**Before the  
FEDERAL COMMUNICATIONS COMMISSION  
Washington, D.C. 20554**

In the Matter of )  
)  
Request by LoJack Corporation for a Partial ) WT Docket 06-142  
Waiver of Section 90.20(e)(6) and Part 2 )  
of the Commission's Rules )  
)

**Petition for Reconsideration of Hammett & Edison, Inc., Consulting Engineers**

This filing is in response to the Commission's September 14, 2011, *Declaratory Ruling and Order*, concerning Stolen Vehicle Recovery System (SVRS) stations at 173.075 MHz.

Representative Spectrum Figures from the Cited OET Report 07-TR-1003

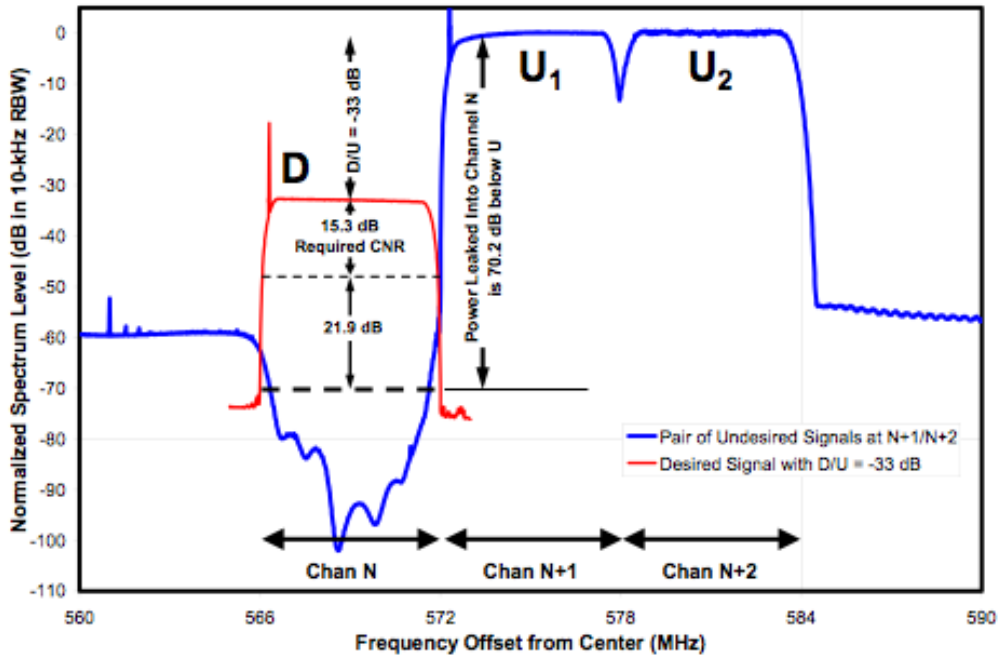
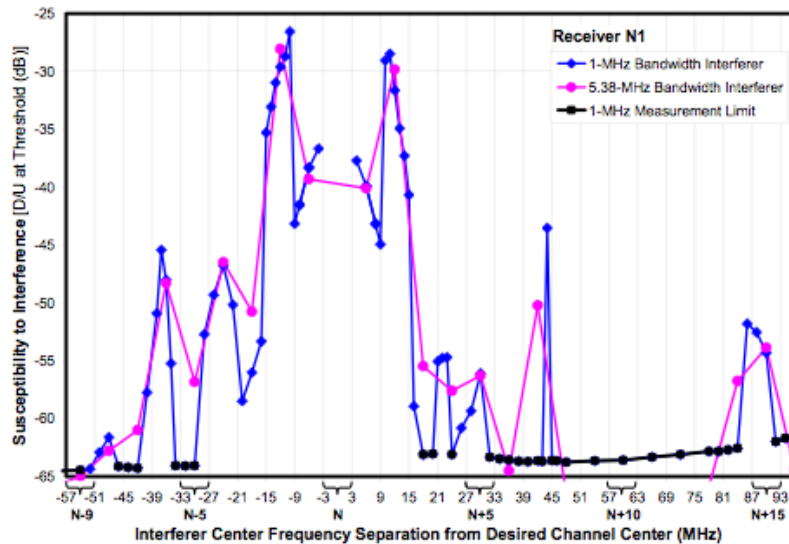
9. The vast majority of the OET testing was based on analog-into-DTV, and DTV-into-DTV testing; that is, one 6 MHz wide TV channel into another 6 MHz wide TV channel. Attached Figure 1 shows two representative spectrum figures from the OET Report. Although there was limited testing of a hypothetical Lower 700 MHz band interfering signal into a DTV Channel 51 receiver, that interfering signal was assumed to be a 1 MHz wide, noise-like signal.<sup>9</sup> A LoJack signal is not a 1 MHz wide, noise-like signal; it is a narrow band, concentrated energy signal. Further, as shown in OET Report Figure 7.1, at some frequencies a 1 MHz wide, noise-like signal was a greater interferer than a 6 MHz wide DTV signal. Therefore, the OET Report demonstrates that there is no basis for the optimistic assumptions made in the DR&O, such as that measurements at UHF would apply equally to measurements at VHF.<sup>10</sup> Indeed, although the OET Report did not include any VHF testing, the report does note that a prior OET investigation of DTV receiver performance for Satellite Home Viewer Extension and Reauthorization Act of 2004 (SHVERA) purposes<sup>11</sup> did include some VHF testing (for receiver sensitivity). But the OET Report notes, at page 5-4, that the SHVERA Report found that:

Thus, the OET Report cited by the DR&O provided a realistic warning about extrapolating UHF measurements to VHF, which the DR&O not only ignored, but adopted in its conclusion the opposite of what the OET Report implied.
